Electricity - Mangalore
Electric Licence,
1930 Amendment

ELECTRICITY - Mangalore Electric License - Waiving of license conditions - Request.

The Mangalore Electric License 1930:
Third Annexure - Amendment.

Electricity - Mangalore Electric Licence. 1930 - Amendment - Sanctioned.

MANGALADEVI KATTA.

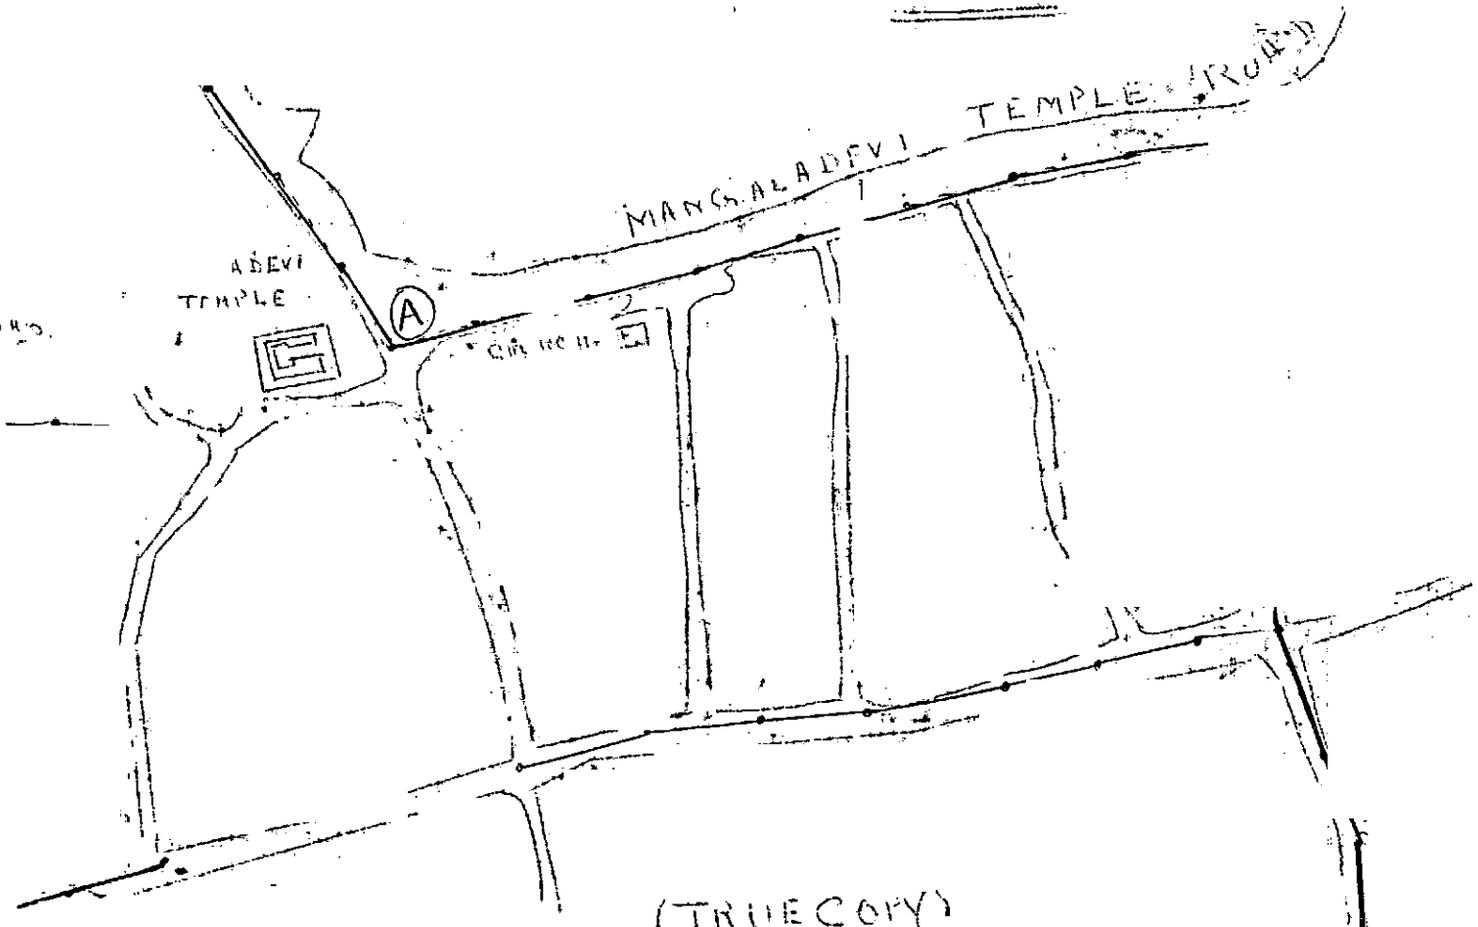
dated 15th June 1937 and the sketch attached to it. On enquiry I find that a small temple car has to pass underneath the electric main somewhere near the point marked 'A' in the second sketch sent by the Resident Engineer. There is also enough room for this to pass underneath these wires. I therefore request that Government may be pleased to waive the provision contained in the 3rd annexure of the license granted to the Company (G.O.No.1379 W dated 6.5.1930) in regard to the Mangaladevi Road i.e. from the Temple to Karnamikatta.

I beg to inform you that I am considering the question of extending our mains in the Mangaladevi Temple Road as shown in Red in the attached sketch.

From the attached sketch you will please see that the proposed overhead mains do not cross the road throughout the route of the Temple Car i.e. from Mangaladevi Temple to Marunemi Katta.

As the cost of laying an underground cable for the anticipated revenue in the roads under consideration, would be prohibitive; I request you to kindly let me know if you would agree to my putting up overhead mains on the southern and eastern side of the roads as shown in the attached sketch.

In the third annexure to the licence, omit the item "(5) Mangaladevi Road from Mangaladevi temple to Mannemikatta."
